# The Calcutta Gazette

## APPENDIX.

### Notices to Mariners.

THE following Notices are republished for general information.

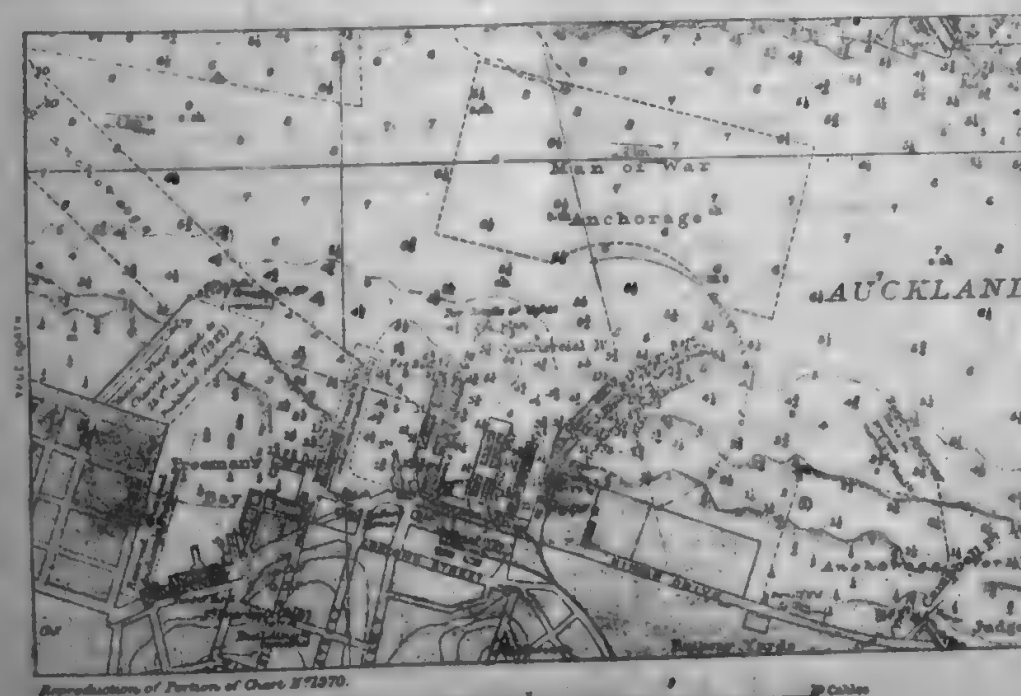
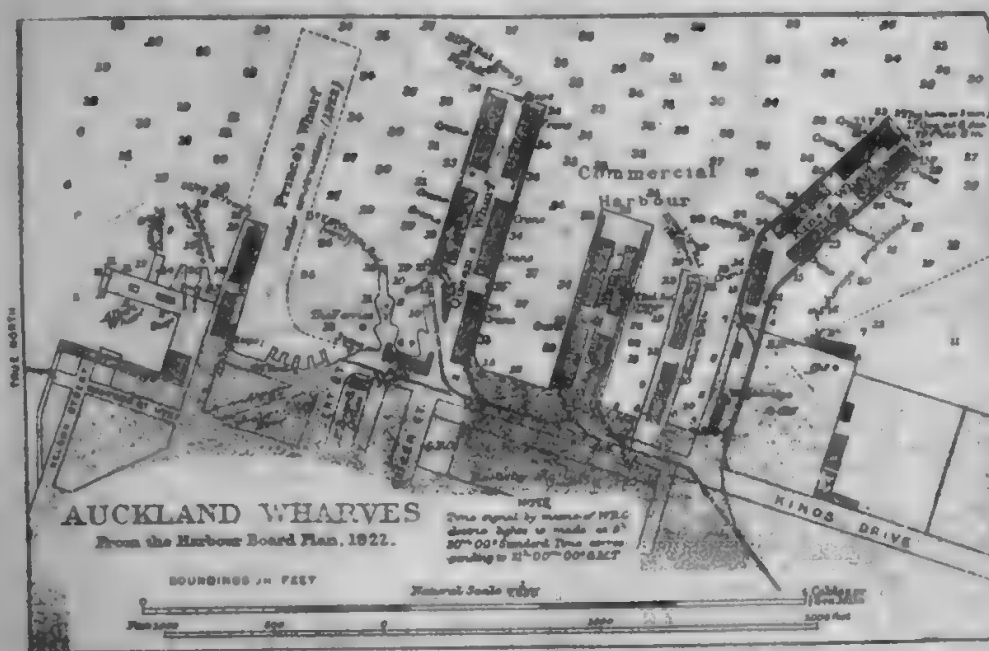
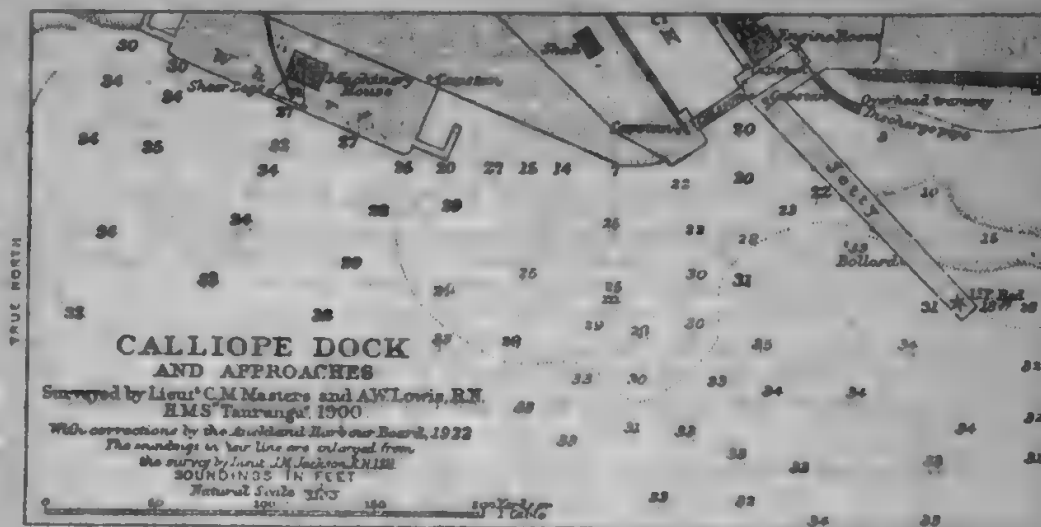
*Details.*—The accompanying reproductions of portions of charts Nos. 1970 and 1896 show necessary amendments to the charts with regard to wharves and depths at Auckland, also amended depths in the approaches to Calliope dock at Devonport.

*Note.*—From the reproductions it will be seen that a *fixed white* light now marks the new Western wharf at Auckland.

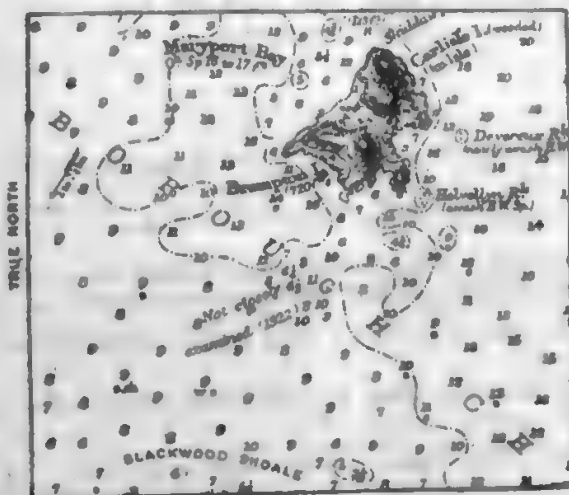
*Details.*—The accompanying reproduction of a portion of chart No. 347 shows the necessary amendments to the chart with regard to decreased depths south-westward of Brampton island.

Reproduction of Portion of Chart No. 2089.

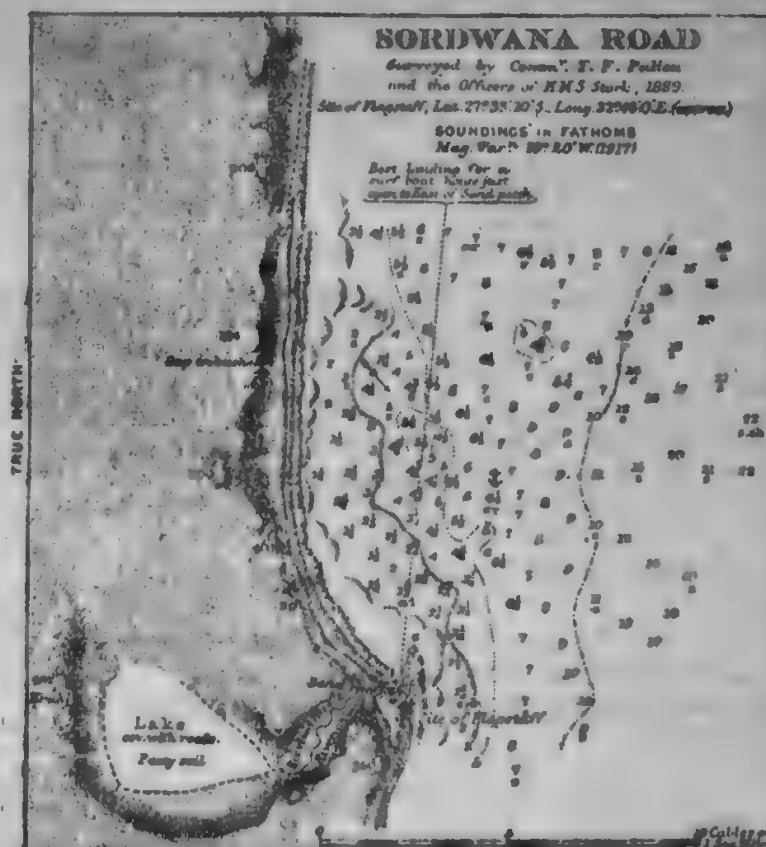
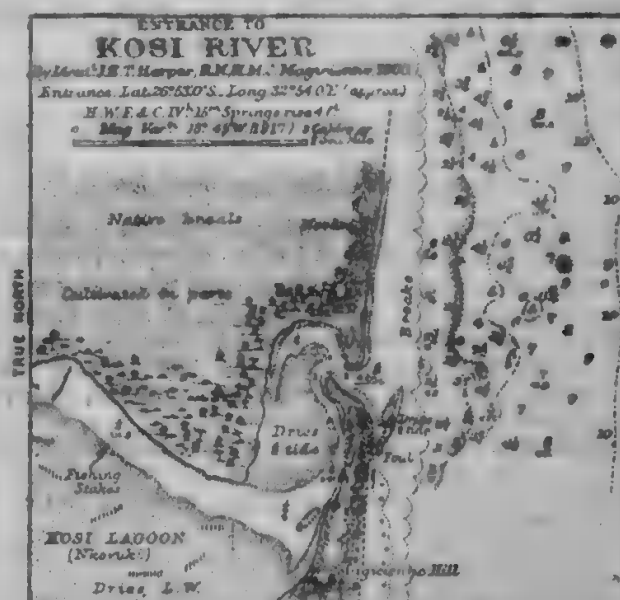
*Details.*—The accompanying reproduction of the plans of Sordwana road and entrance to Kosi river on chart No. 2089 shows the necessary amendments to the chart with regard to shoals and depths in the two localities referred to.

Reproduction of Portion of Chart No. 3642

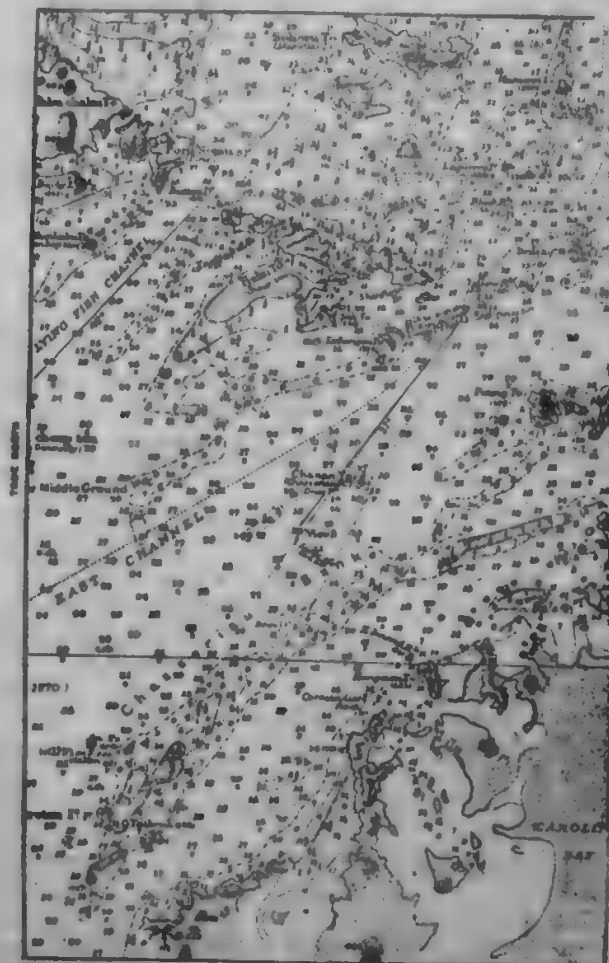
*Details.*—The accompanying reproductions of portions of charts Nos. 3612 and 1258 show the necessary amendments with regard to depths and shoals in East and Flying Fish channels and their vicinities.

*Remarks.*—The above rock and shoal, which are to be inserted on chart No. 3642, are not included in the reproduction of the portion of that chart.

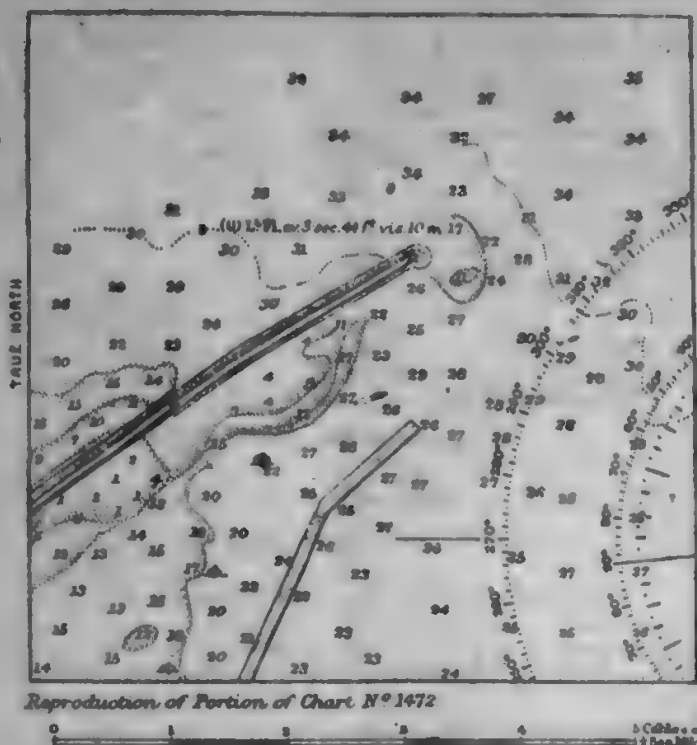
*Details.*—Amendments to the undermentioned plan on chart No. 1472 with regard to the moles, depths and mooring buoys at the entrance to Koombanah harbour, embodying the latest information received, are shown on the accompanying reproduction of a portion of that plan.

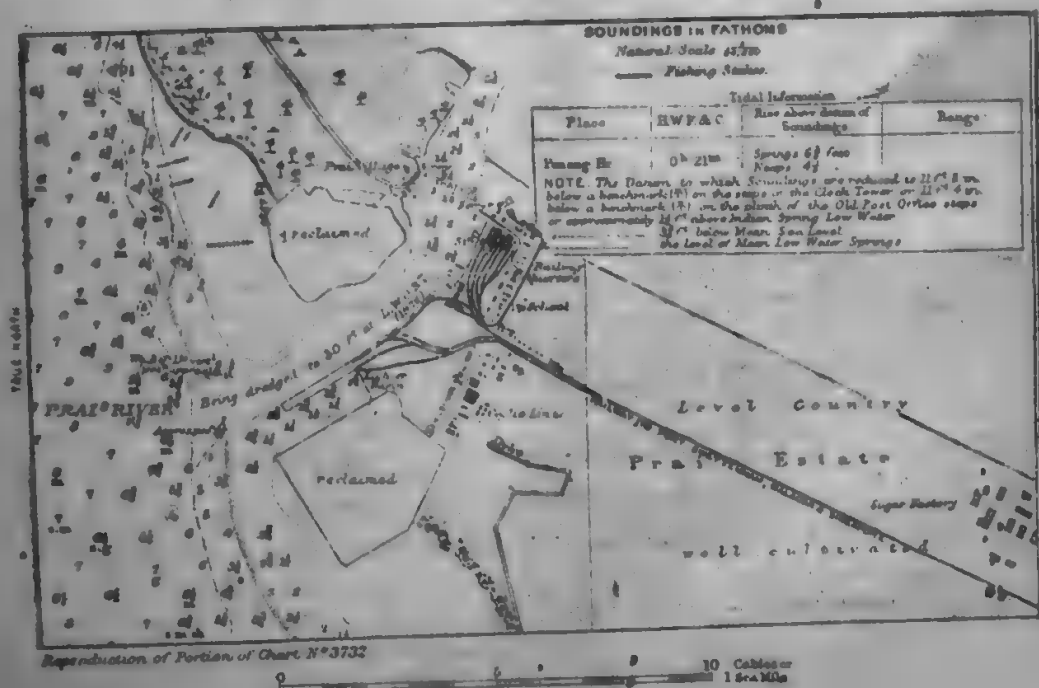
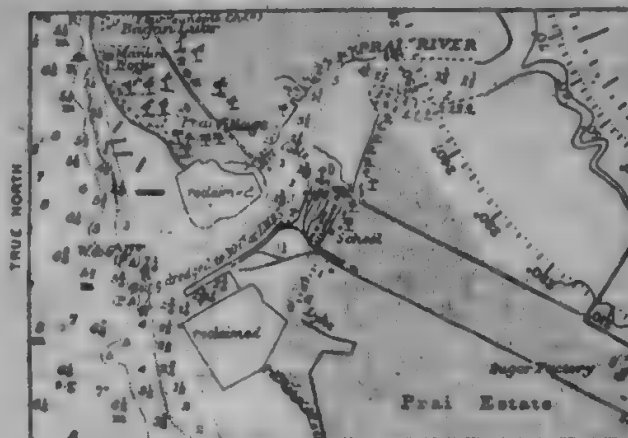
*Details.*—General amendments to the charts in regard to Prye river entrance, embodying the latest information received, are shown on the accompanying reproductions of portions of charts Nos. 3732 and 1366.

Reproduction of Portions of Chart No. 2089.

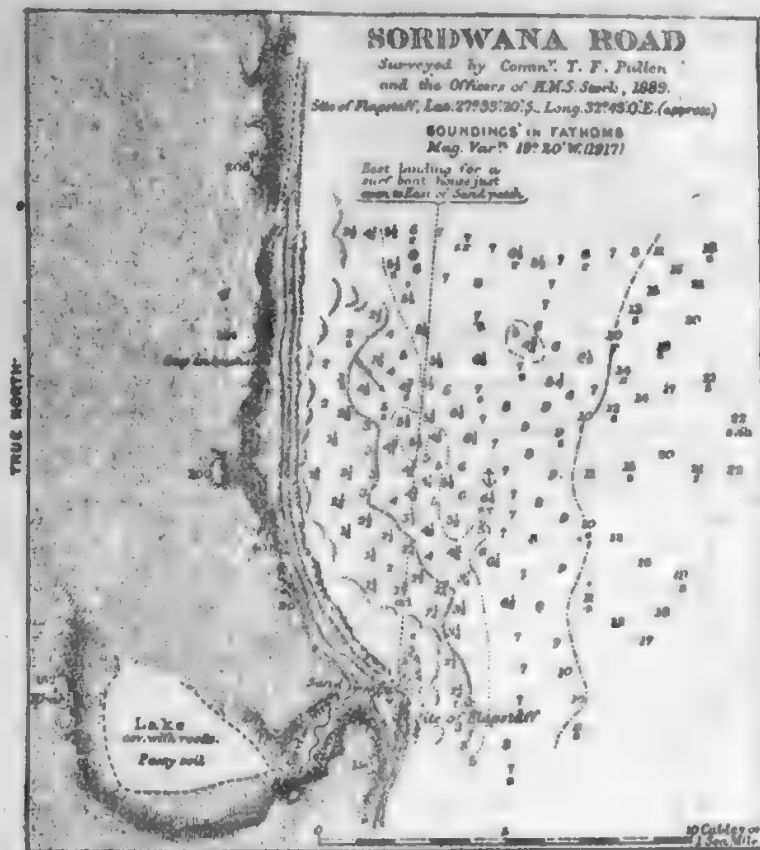
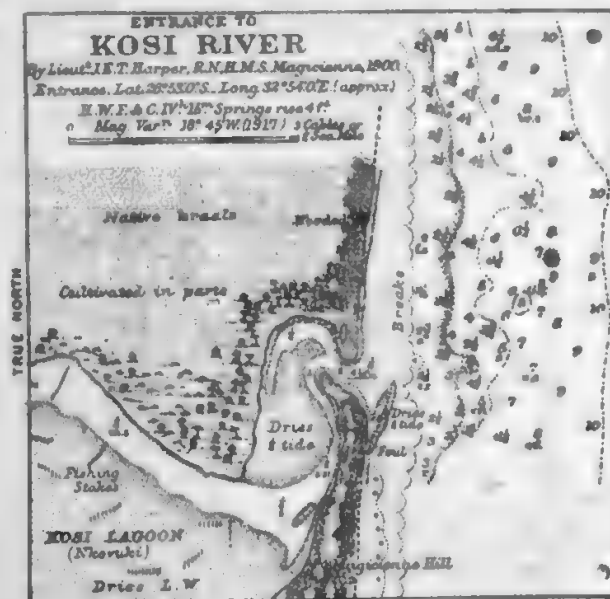
*Details.*—The accompanying reproduction of the plans of Sordwana road and entrance to Kosi river on chart No. 2089 shows the necessary amendments to the chart with regard to shoals and depths in the two localities referred to.

Reproduction of Portion of Chart No. 3642

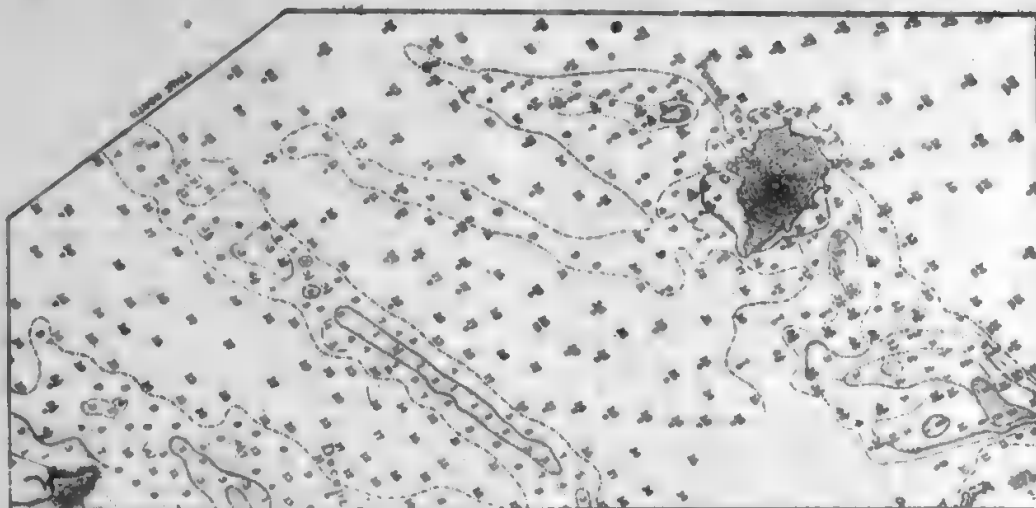
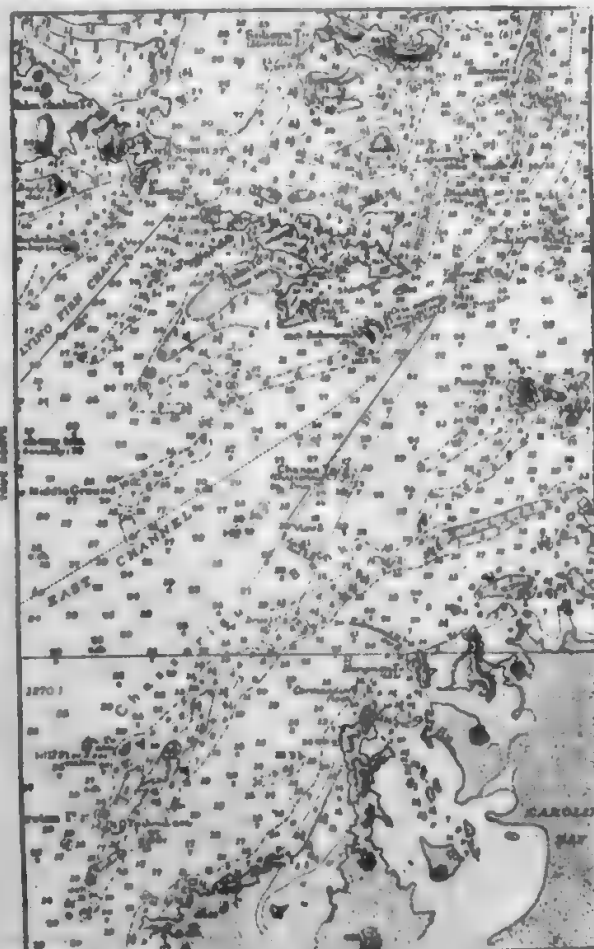
*Details.*—The accompanying reproductions of portions of charts Nos. 3642 and 1258 show the necessary amendments with regard to depths and shoals in East and Flying Fish channels and their vicinities.

*Remarks.*—The above rock and shoal, which are to be inserted on chart No. 3642, are not included in the reproduction of the portion of that chart.

*Reproduction of Portion of Chart N° 3440.*

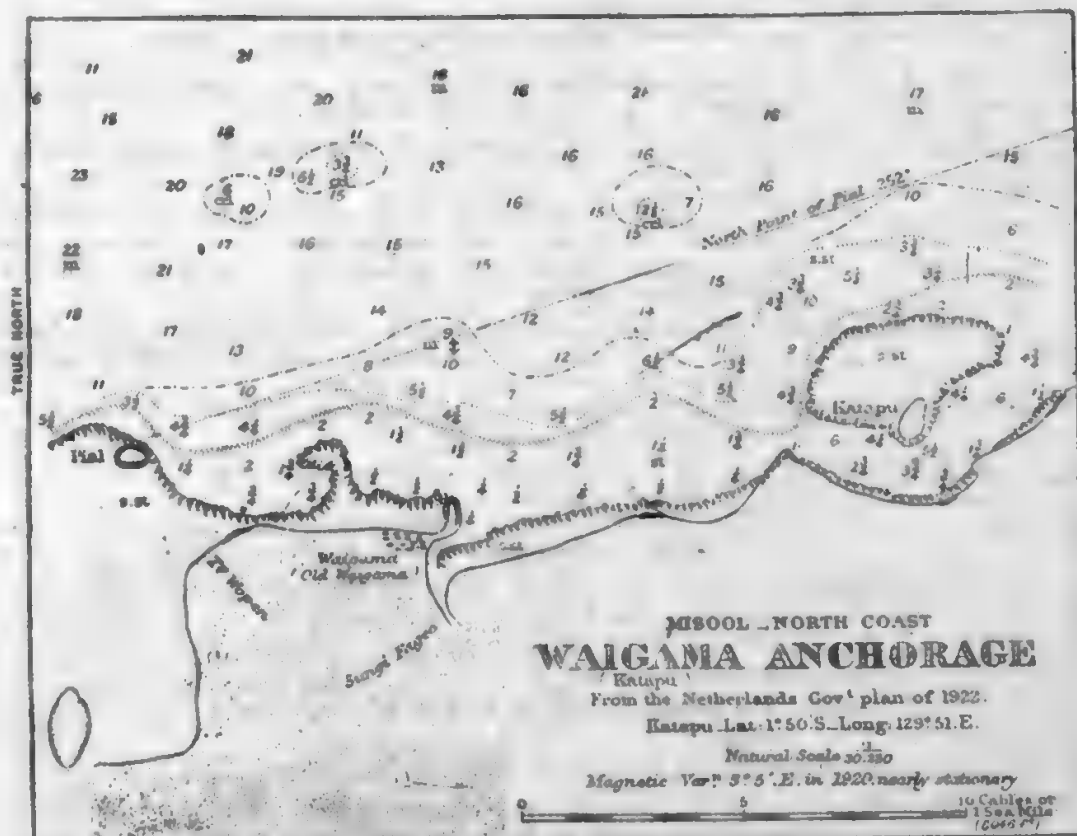
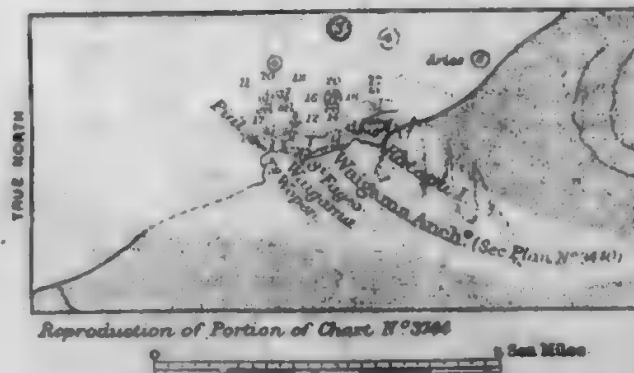
*Details*.—The accompanying reproduction of portions of charts, Nos. 3440 and 3744 show the necessary amendments with regard to Waigama (Katapu) anchorage. The existing plan of Katapu (New Waigama) anchorage on chart No. 3440 is to be replaced by the new plan of Waigama (Katapu) anchorage.

Reproduction of Portion of Chart N° 3440.

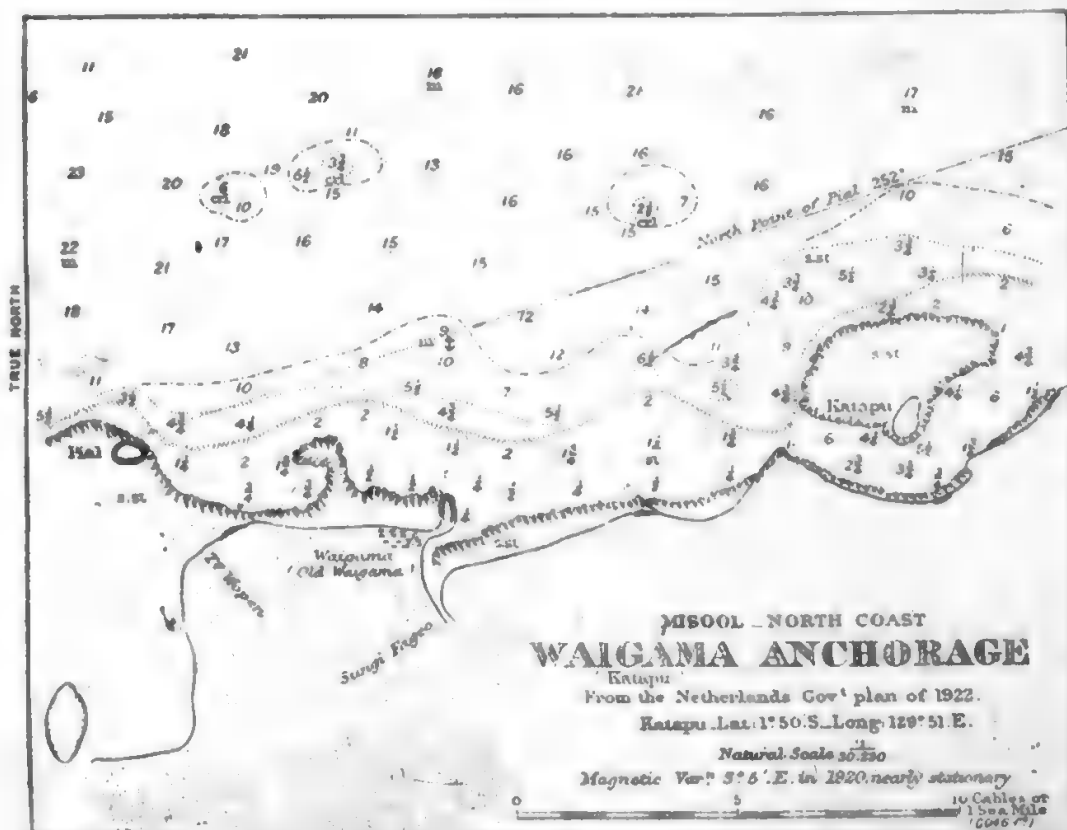
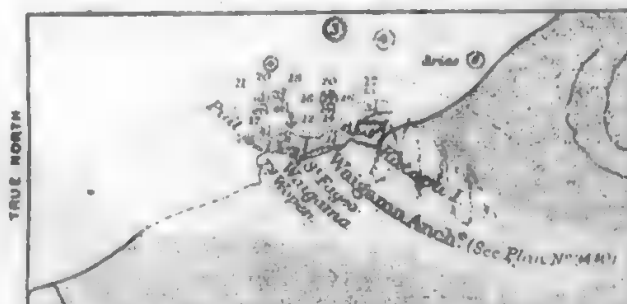
*Details.*—The accompanying reproduction of portions of charts, Nos. 3440 and 3744 show the necessary amendments with regard to Waigama (Katapu) anchorage. The existing plan of Katapu (New Waigama) anchorage on chart No. 3440 is to be replaced by the new plan of Waigama (Katapu) anchorage.
